MISSISSAUGA BUS RAPID TRANSIT

ENVIRONMENTAL ASSESSMENT ADDENDUM

March 2010

McCormick Rankin Corporation
in association with
Ecoplans, Ltd.

MRC	MISSISSAUGA Transportation and Works	DATE: February 2009	MISSISSAUGA BRT PROJECT ENVIRONMENTAL ASSESSMENT ADDENDUM	FIGURE 8-2
	GO Transit	SCALE: 1:3,000	DIXIE ROAD / EASTGATE PARKWAY RECOMMENDED ALTERNATIVE - DIXIE STATION

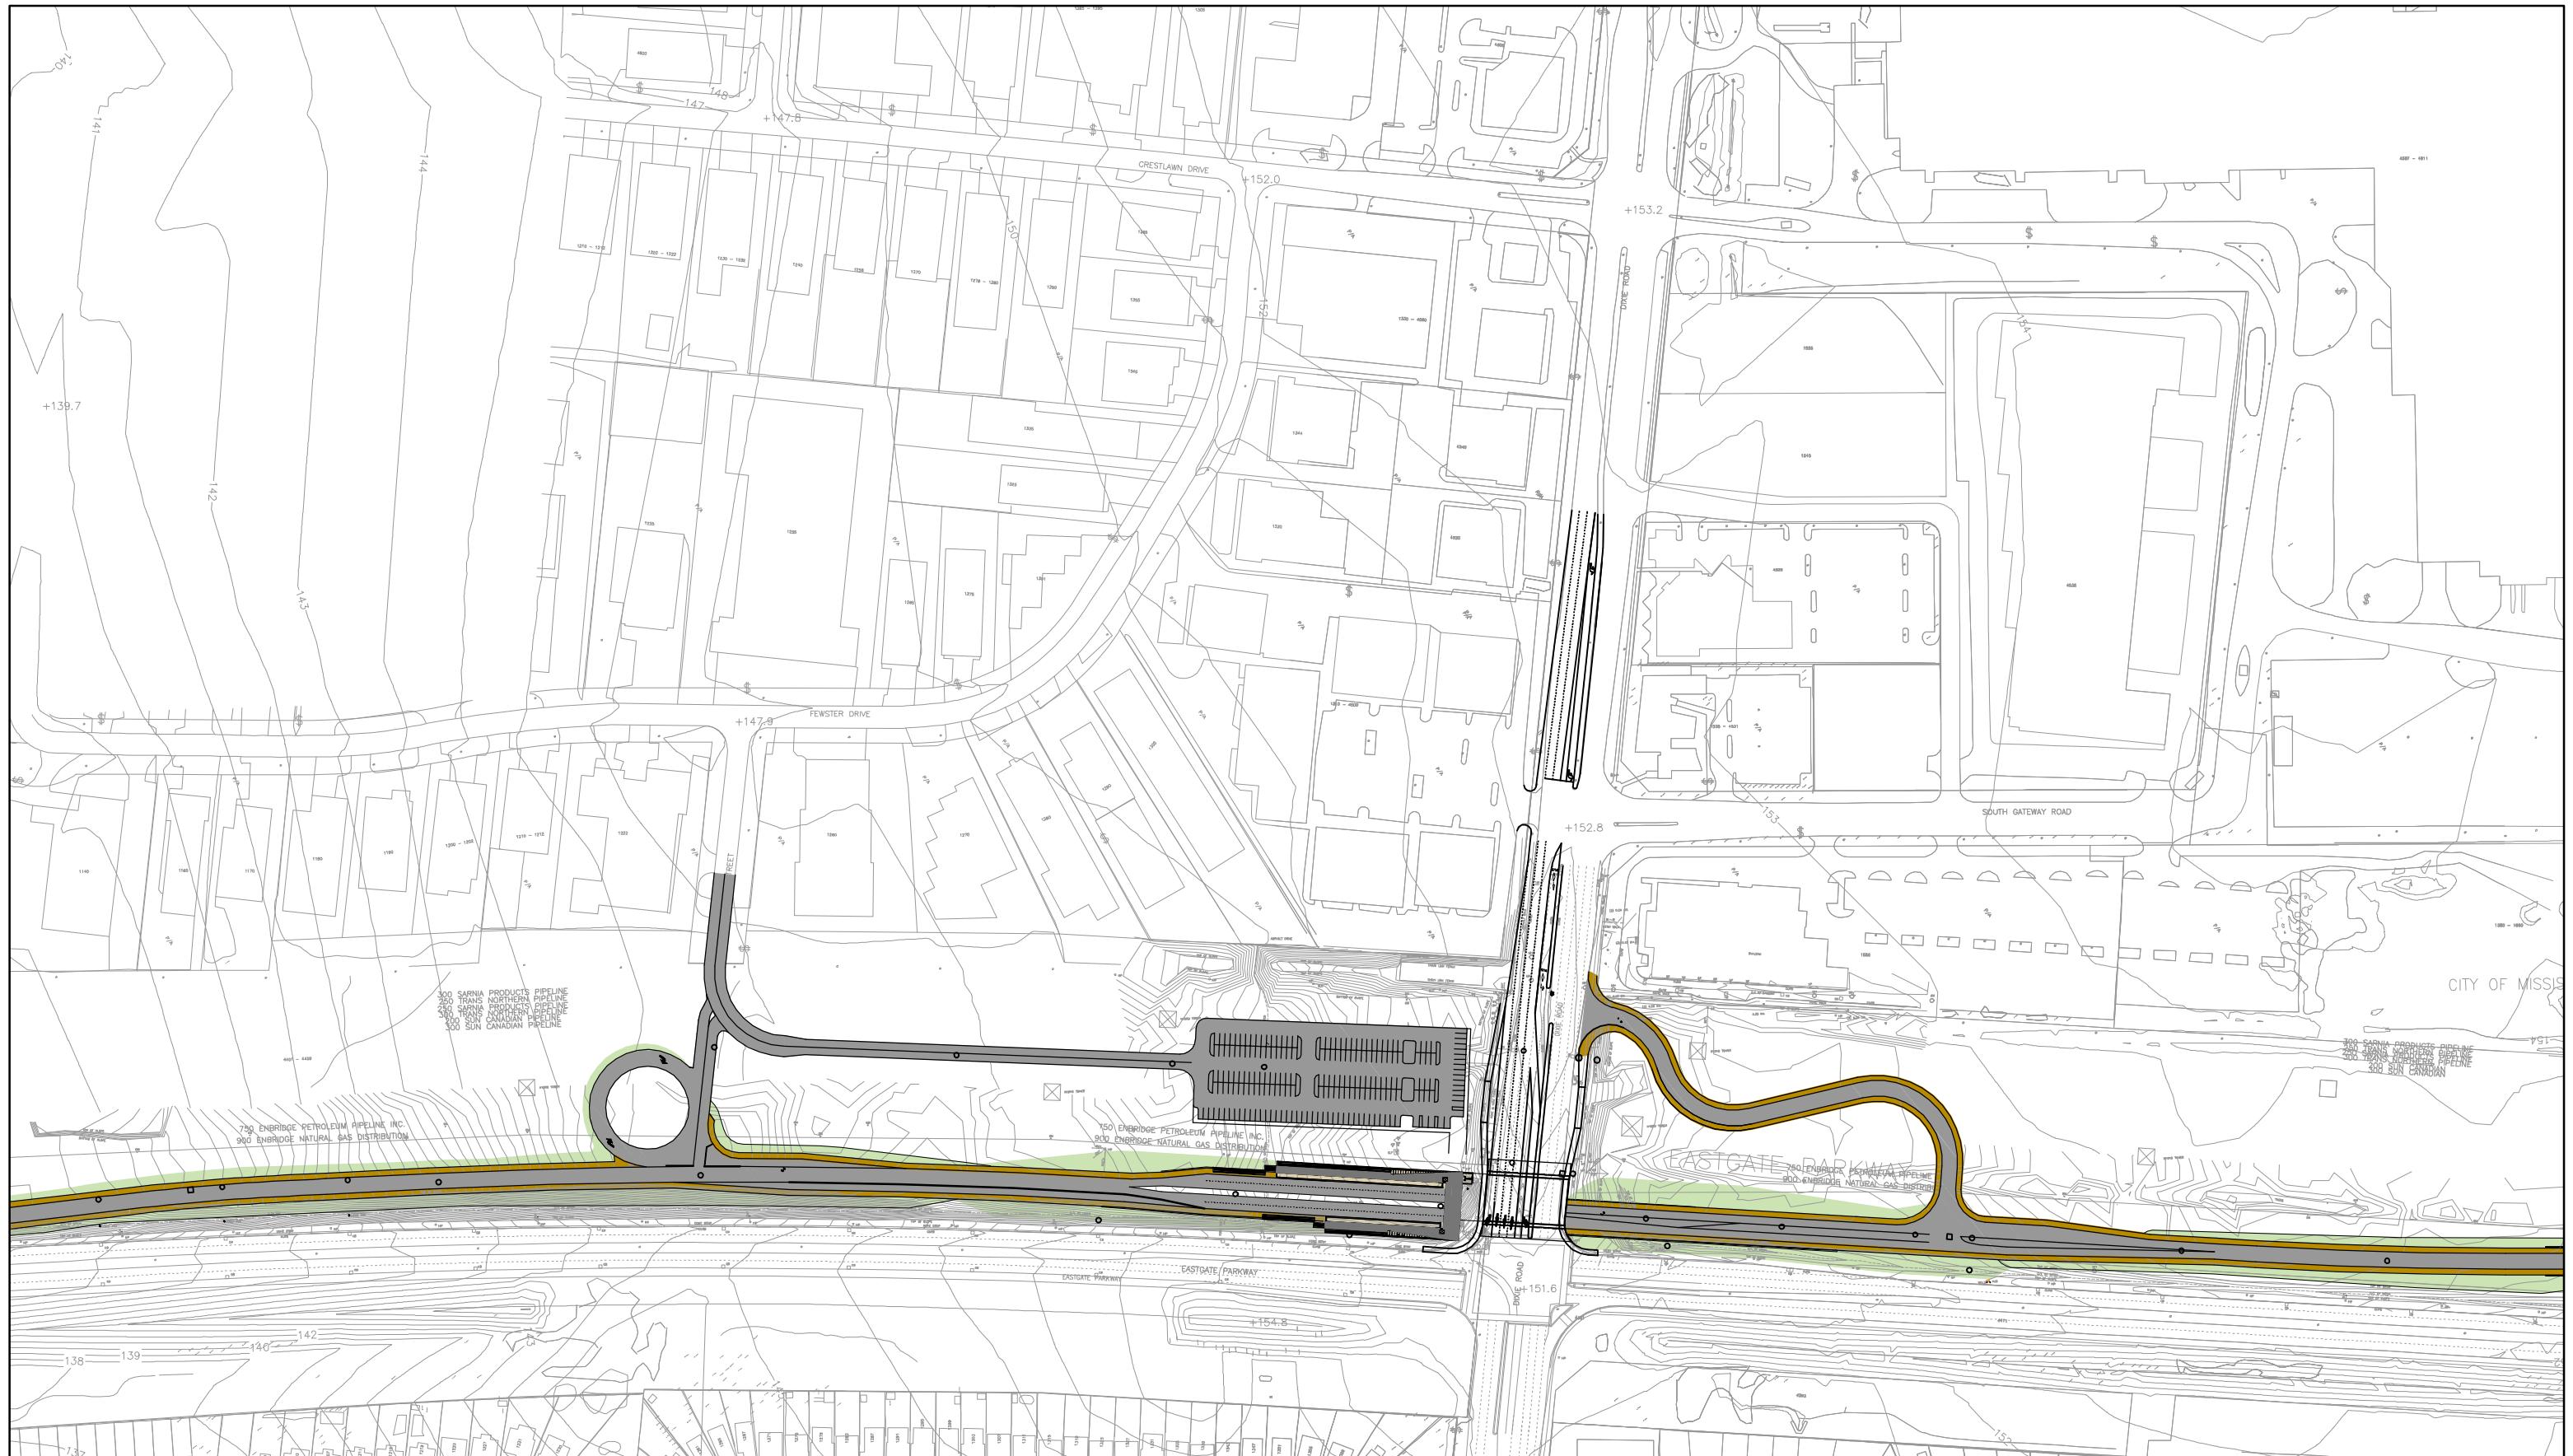
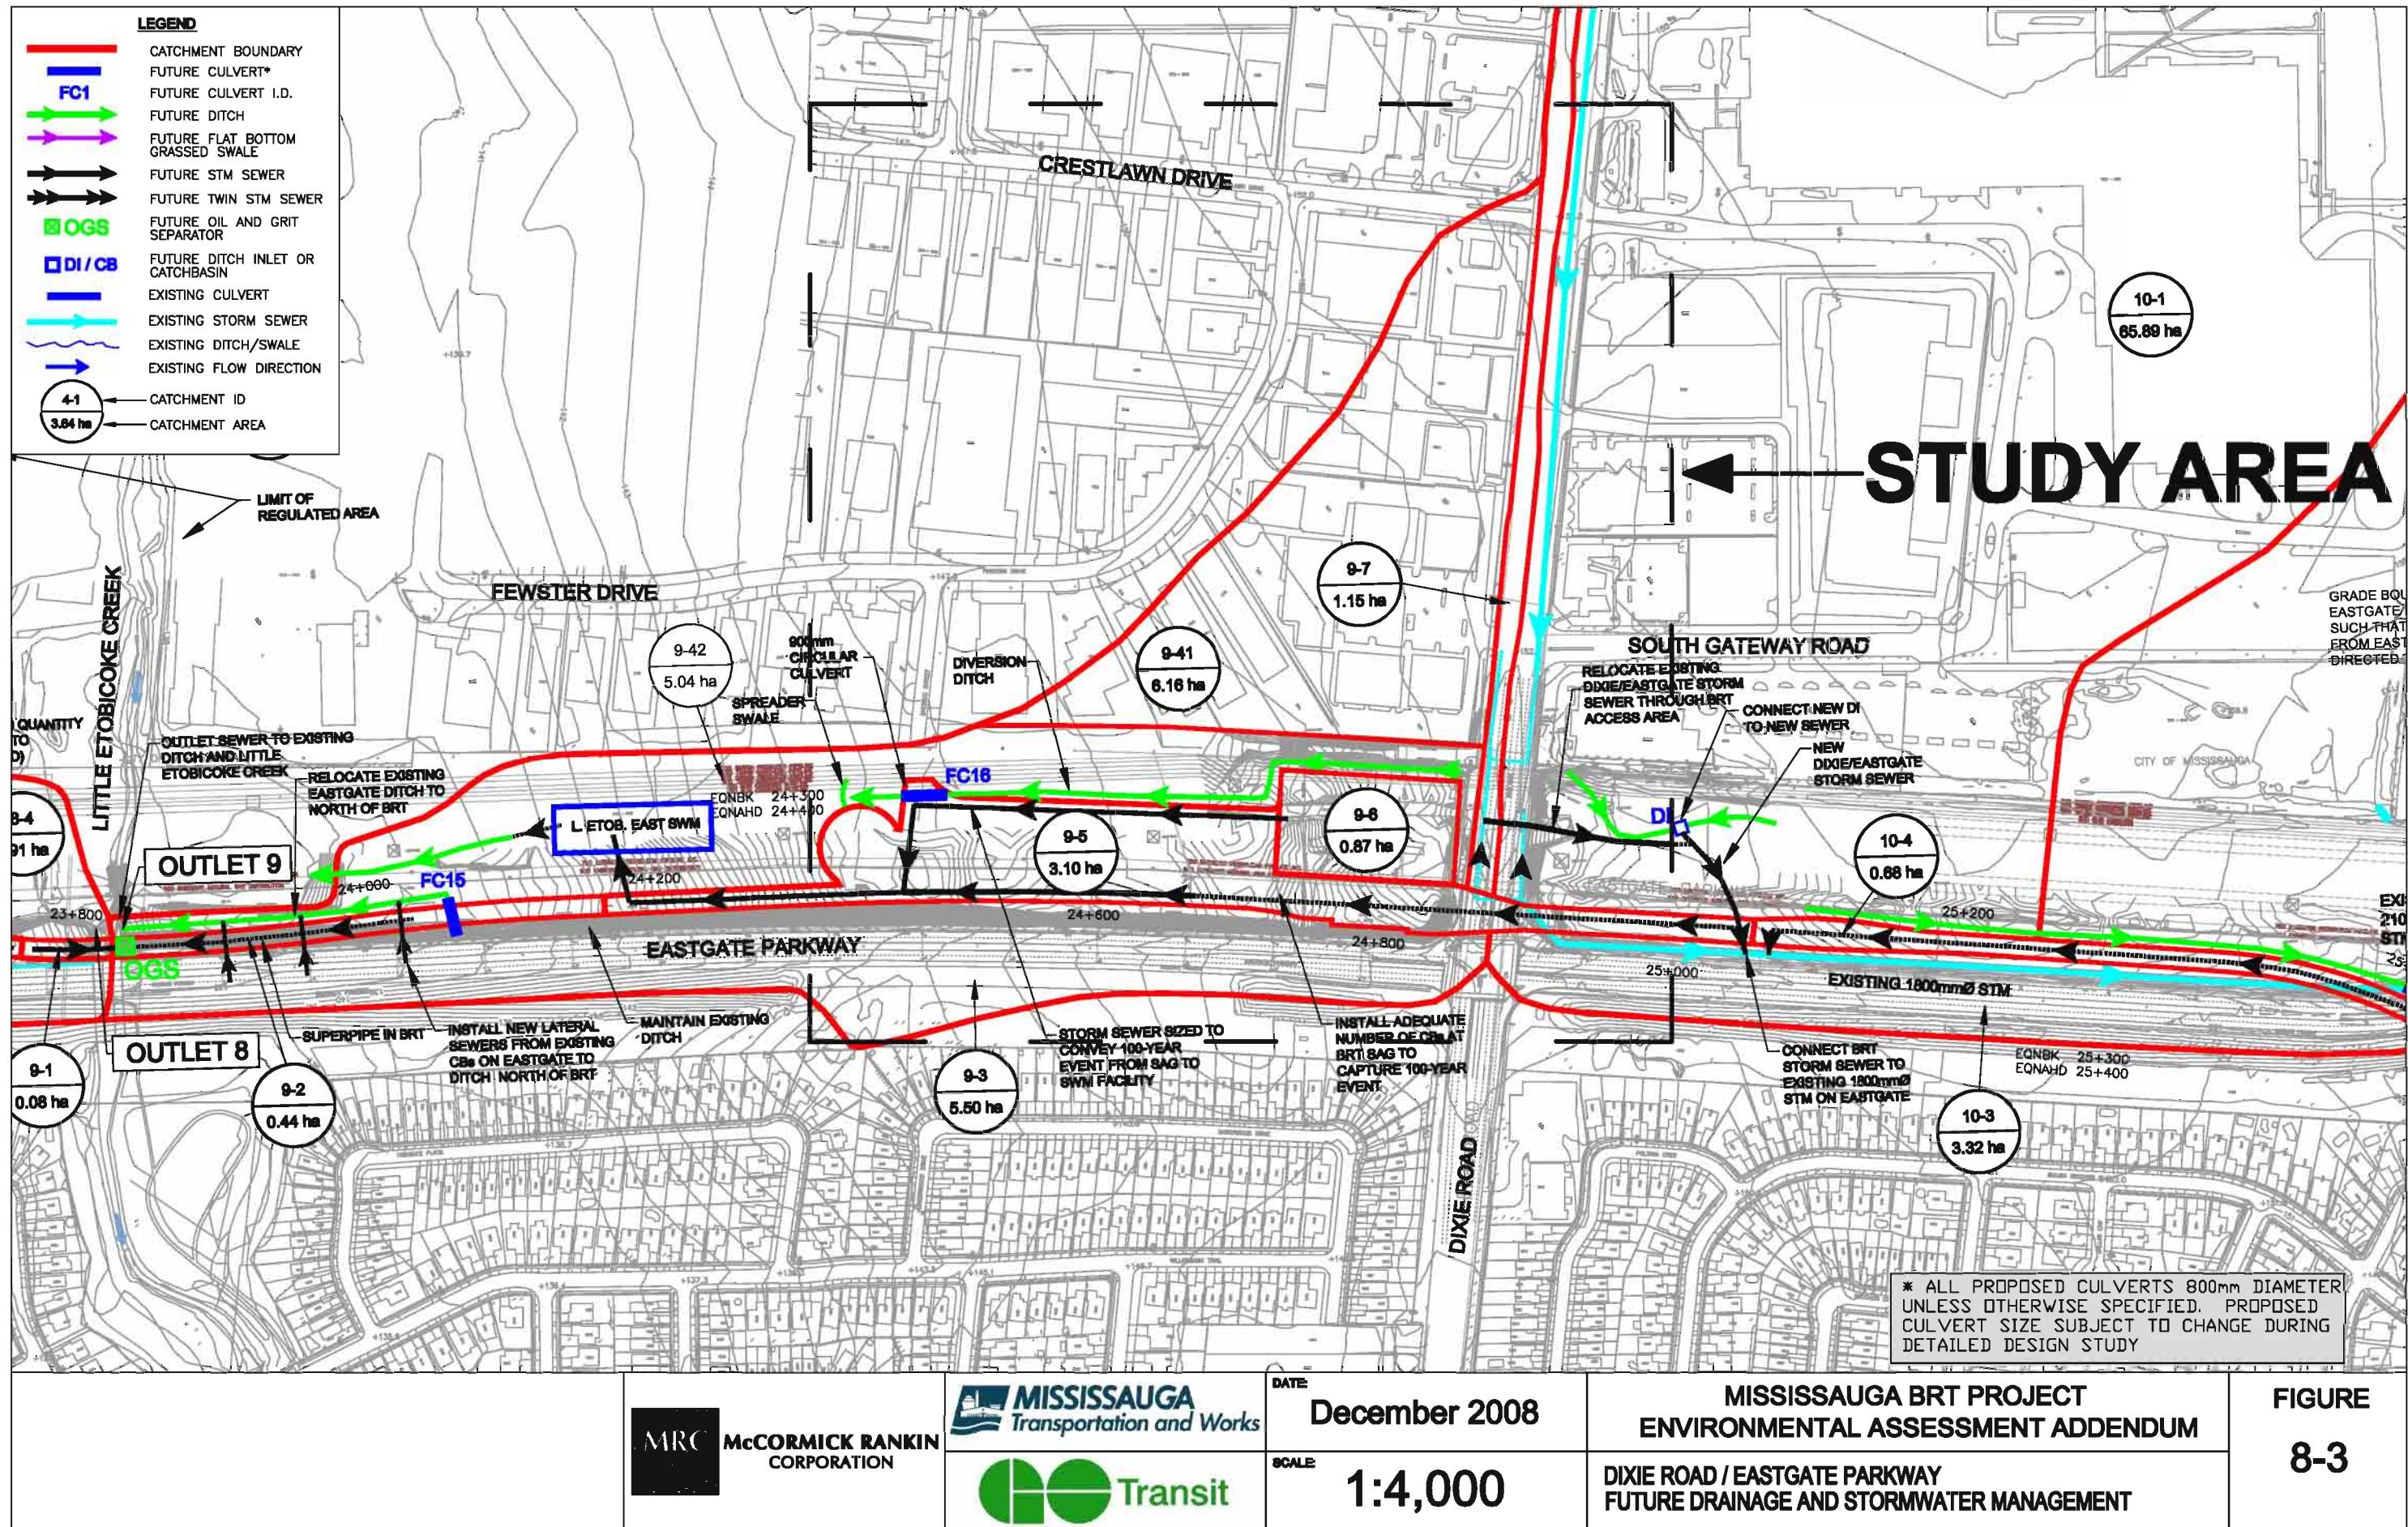
The hydro corridor, immediately north of the proposed busway, contains a number of significant subsurface oil and gas pipelines, as indicated on Figures 8-1 and 8-2. The proposed busway access links from Dixie Road need to be repositioned (from those indicated in the Base Case plan) to avoid conflicting with the pipelines. The revised bus ramps are therefore lengthened and further separated from Dixie Road, thereby providing enough distance from the Dixie Road grade-separation to bring the busway up to grade and allow the ramp connections to pass over the existing pipelines.

It is recommended that the three improvements outlined above (Section 8.2) be implemented at the Dixie station site. The recommended alternative is shown on Figure 8-2.
